FLIGHT READINESS STATEMENT
STS-94/ET-86 AND STS-85/ET-87
EXTERNAL TANK PROJECT
PRE-FLIGHT REVIEW

EXTERNAL TANKS ET-86/STS-94 AND ET-87/STS-85, AS IDENTIFIED IN THE EXTERNAL TANK PROJECT PRE-FLIGHT REVIEW DATED JUNE 11, 1997, ARE CONSIDERED READY TO SUPPORT FLIGHT UPON ACCEPTABLE DISPOSITION OF OPEN/PLANNED WORK AND/OR OPEN ACTIONS.

Space Shuttle
External Tank

STS-94/ET-86 and STS-85/ET-87 Pre-Flight Review

Increase LO2 Tank Aft Dome Foam Coverage

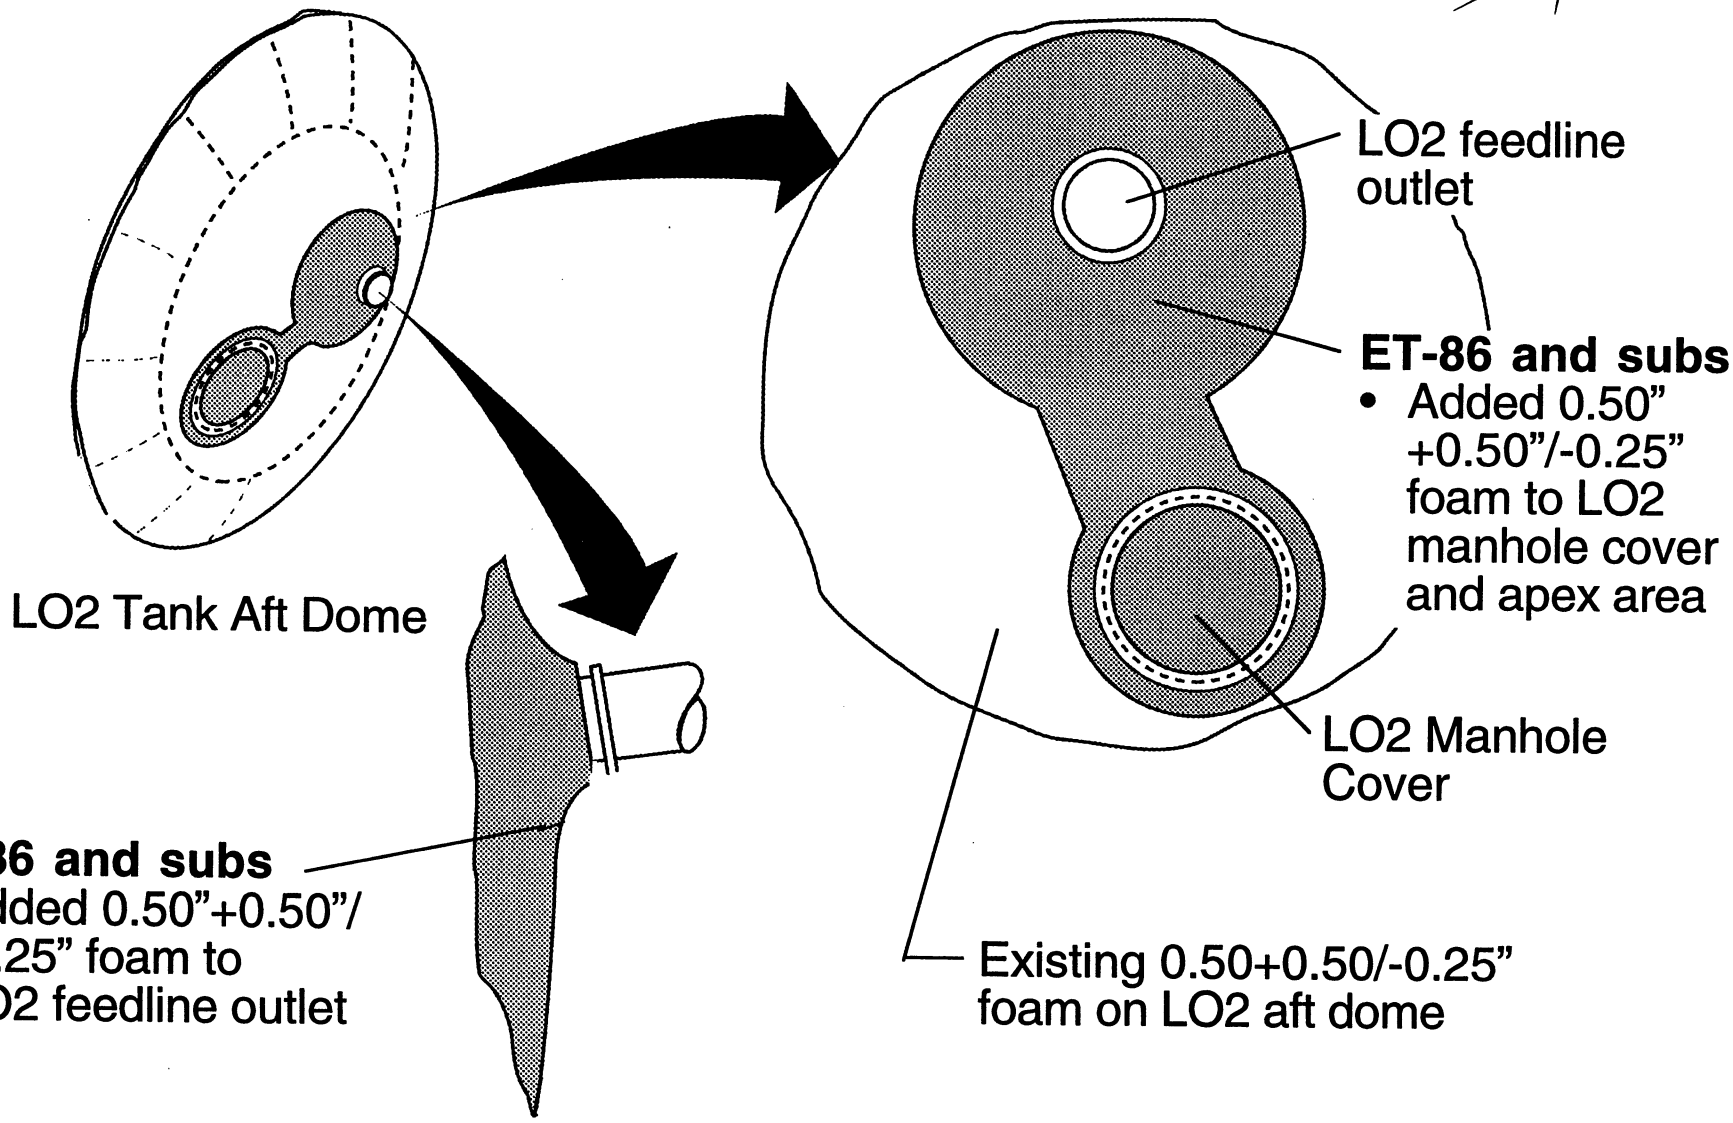
- Increase foam coverage on LO2 aft dome in area around manhole cover and feedline fitting

- Apply BX-250 foam on LO2 manhole cover, LO2 feedline outlet and area between the cover and fitting
- Added requirement to ensure 1.10" gap exists between SRB beam and LO2 aft dome foam

- Analysis
  - Stress, FS:
    - Required = 1.10
    - Actual = 2.39 (failure mode: bondline delamination)
  - Thermal: Reduces heat leak and provides denser propellant and added performance margin to heated Intertank purge system
  - Propulsion: Additional LO2 load provides potential for increased performance
- Acceptance: Lead in/lead out plug pulls
- Approved by Level II PRCB (S052333JR9) on 4/13/95

Alternate Blowing Agent Foam Implementation

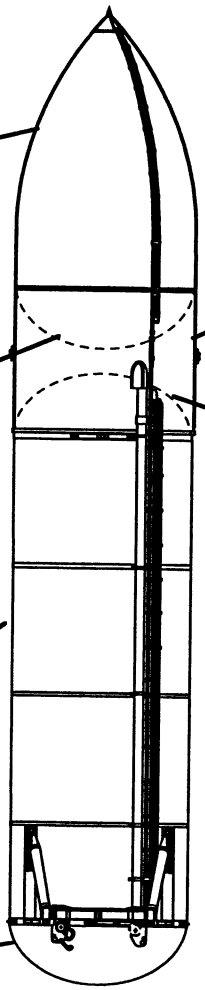
Implement use of alternate blowing agent foams
- ET-86 and subs: NCFI 24-124 on LO2 tank sidewall
- ET-87 and subs: SS-1171 on LO2 aft dome

- Replaced CFC-11 in all ET foams with HCFC-141b
  - CPR-488 replaced with similar polyisocyanurate foam NCFI 24-124
  - BX-250 replaced with similar urethane foam SS-1171

Delete LO2 Tank Slosh Baffle Section

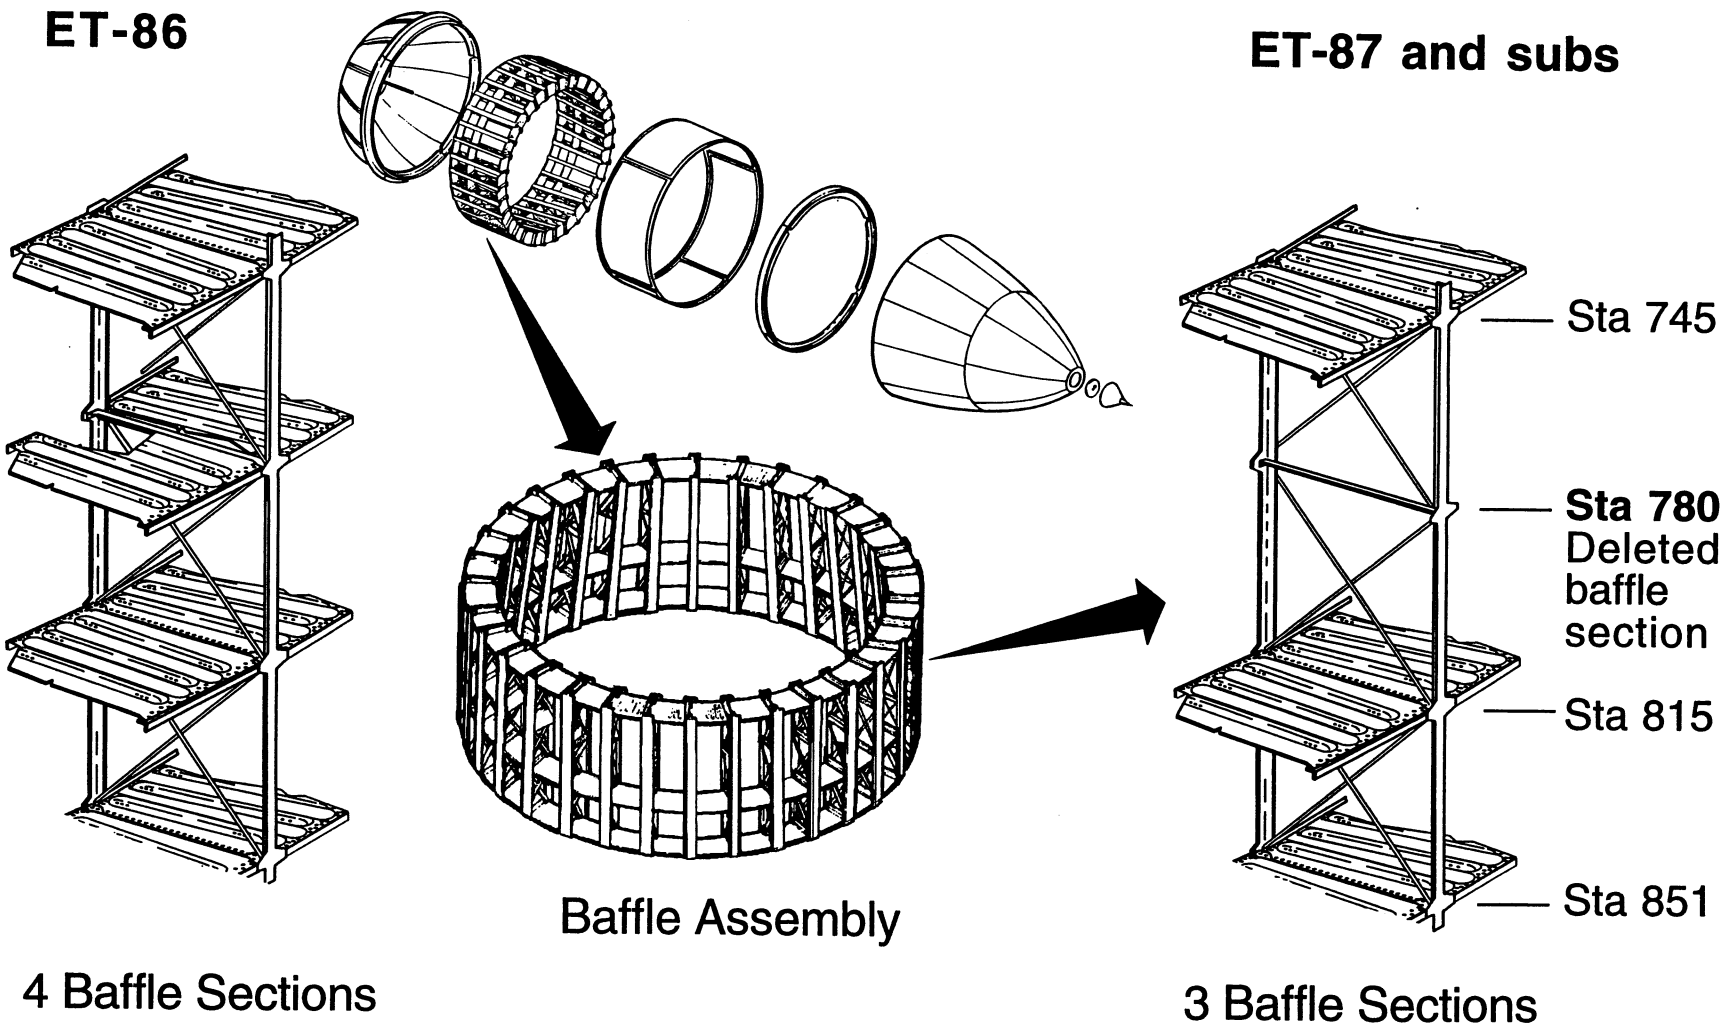
- Deleted slosh baffle section on LO2 tank at Station 780 resulting in change to available damping

- Removed one slosh baffle section at Station 780
  - Was: 4 baffle sections
  - Now: 3 baffle sections

- Analysis
  - Dynamics: Damping available for flight control remains within requirements
  - Propulsion:
    - Normal mission and RTLS tank ullage predictions remain within ICD limits
  - Stress: Meets required FS of 1.40
    - ET-86 with 4 baffle sections: FS = 3.35
    - ET-87 with 3 baffle sections: FS = 2.02 (failure mode: column buckling inboard stringer)
- CR S052333BM approved by Level II
